# United States Patent and Trademark Office

APPLICATION NO.	FILING DATE	FIRST NAMED INVENTOR	ATTORNEY DOCKET NO.	CONFIRMATION NO.
10/519,906	02/04/2005	Alexandre Cury Schmid	04304/0202236-USO	2918
7278 DARBY & DA	7590 12/28/2007		EXAM	INER
DARBY & DARBY P.C. P.O. BOX 770			NALVEN, EMILY IRIS	
Church Street Station New York, NY 10008-0770			ART UNIT	PAPER NUMBER
			3744	
			MAIL DATE	DELIVERY MODE
			12/28/2007	PAPER

### **DETAILED ACTION**

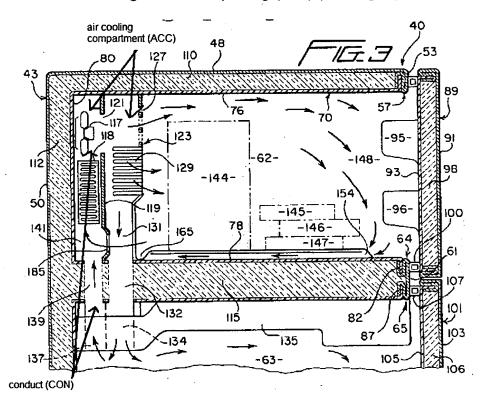
Mandel et. al. also teach one end (139) opening maintained in communication with the refrigerating compartment (63) (see Fig. 3), and at least one fan (117) producing a forced airflow from the air-cooling compartment (ACC, see annotated Fig. 3 below) to the freezing compartment (62) and to the refrigerating compartment (63) (see Fig. 3 and col 4 lines 23-26), characterized in that the distributing duct (131) carries a conduct (CON, see annotated Fig. 3 below) having a first end (side further from fan 117) coupled to the end Opening of the distributing duct (131) (see Fig. 3) and a second end (side closest to fan 117) selectively placed in fluid communication with one of the parts (121) defined by the distributing duct (131) and by the air-cooling compartment (ACC, see annotated Fig. 3 below). (col 4 lines 29-34 and see Fig. 3), said • conduct being internal to the distributing duct (131) (see Fig. 3).

In regard to claim 2, Mandel et. al. teach the air distribution system characterized in that the conduct (CON, see annotated Fig. 3 below) is incorporated to the distributing duct (131) (see Fig. 3). It is interpreted that the term "incorporated" means the distributing duct (131) and conduct (CON) are placed side by side in the same air-cooling compartment (ACC).

In regard to claim 3, Mandel et. al. teach the air distribution system characterized in that the distributing duct (131) comprises a rear basic portion (78) (see Fig. 2 and col 5 lines 36-39) in the form of a vertically disposed tray (154) having a rear wall (50) provided with a rear window (185) (see Fig. 3 and col 5 lines 55-56) and defining at least part of a front wall (61) of the air-cooling

compartment (ACC, see annotated Fig. 3 below) and a front cover portion (64, 65) to be seated and affixed against the rear basic portion (78) and being provided with at least one front opening (101) (see Fig. 3 and col 3 lines 42-44). In regard to claim 4, Mandel et. al. teach the air distribution system characterized in that the front cover portion (89) defines a wall portion of the conduct (CON, see annotated Fig. 3 below) when assembled (see Fig. 3). In regard to claim 5, Mandel et. al. teach the air distribution system characterized in that the conduct (CON, see annotated Fig. 3 below) is maintained in selective fluid communication with one of the parts (118) defined by the distributing duct (131) and by the air-cooling compartment (ACC, see annotated Fig. 3 below) by means of respective front opening (89, 101) and rear opening (134) produced by the rupture of corresponding wall portions of the conduct (CON) (see annotated Fig. 3 below).

In regard to claim 6, Mandel et. al. teach the air distribution system characterized in that the conduct (CON, see annotated Fig. 3 below) conducts a forced airflow supplied through the inlet (132) opening coming from the distributing duct (131) to whose rear window (127) is operatively associated a fan (117) (see Fig. 3 and col 4 lines 54-56).

In regard to claim 7, Mandel et. al. teach the air distribution system characterized in that the conduct (CON, see annotated Fig. 3 below) conducts a forced airflow which is produced by a fan (117) that is operatively associated to the end opening (132) and to the refrigerating compartment (63) and which is

supplied by the air-cooling compartment (ACC, see annotated Fig. 3 below) to the conduct through the rear opening (134) (see Fig. 3).
